LiFT Pack S-Series Technical Bulletin

SUBJECT: Positively Charged Case

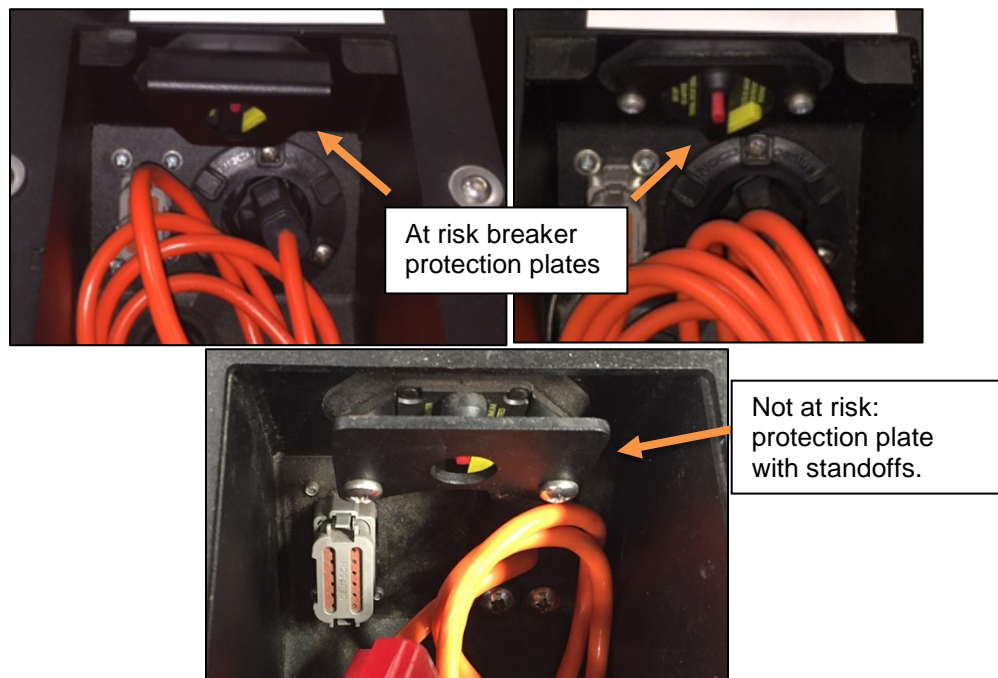
The pack arcs with the truck chassis, the main fuse blows or the breaker pops.

In some cases, the bolts used to mount the breaker are longer than necessary, creating a risk of contact internally with the lugs bolted to the breaker. If they come in contact, over time the insulation may wear through creating contact between the positive battery lead and the breaker bolt, energizing the battery case. This issue increases the possibility of a blown fuse, and may affect truck operation if the truck chassis is tied to battery ground (battery negative).

UL Listed LiFT Packs with serial numbers 160011-160345 are susceptible unless they have the breaker protection plate with standoffs located in the cable storage box and pictured below.

For LiFT Packs in stock or being maintained for other reasons, they should have the bolts checked, and if necessary replaced or cut to the appropriate size.

1. Press the red breaker button to turn off the battery
2. Remove the 16 lid bolts, lift the lid off the battery and rest it on the side of the battery case.
3. Remove the two lugs/nuts on the back of the breaker.
 △Tape the lugs to prevent arcing△.
4. Remove the nuts holding the breaker to the battery lid. There may be water proofing which must be cut away.
5. Cut the bolts to the appropriate size, or replace them with bolts that are 10-32 7/8".
6. Tighten nuts back onto bolts.
7. Apply silicon rubber around the back of the breaker if the pack is going to be put in a power washing environment.
8. Bolt the the two lugs to the breaker
9. Re-install the battery lid
